Raspberry Pi Camera Module 2

PCN 62 – Change of sensor to Sony
IMX355

Product Change Notification

Change of sensor to Sony IMX355

Table 1.
Comparison Images

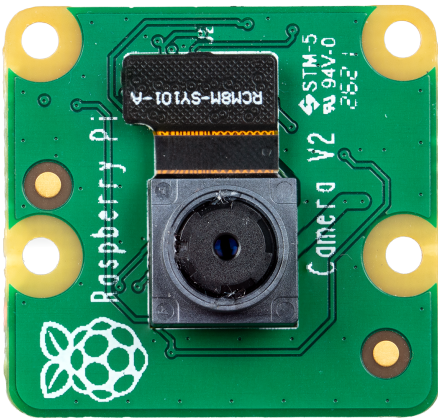
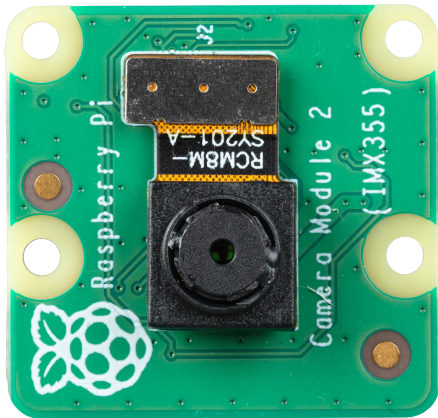
The new product can be distinguished by visual examination or by software.

Original Part	New Part
 The image shows the back of a Raspberry Pi Camera V2 module. It is a green PCB with a black camera lens in the center. Text on the PCB includes 'Raspberry Pi' and 'Camera V2'. A small black component is labeled 'RCM8M-SY101-A' and 'STM-5 94V-0'.	 The image shows the back of a Raspberry Pi Camera Module 2 (IMX355) module. It is a green PCB with a black camera lens in the center. Text on the PCB includes 'Raspberry Pi' and 'Camera Module 2 (IMX355)'. A small black component is labeled 'RCM8M-SY201-A'.
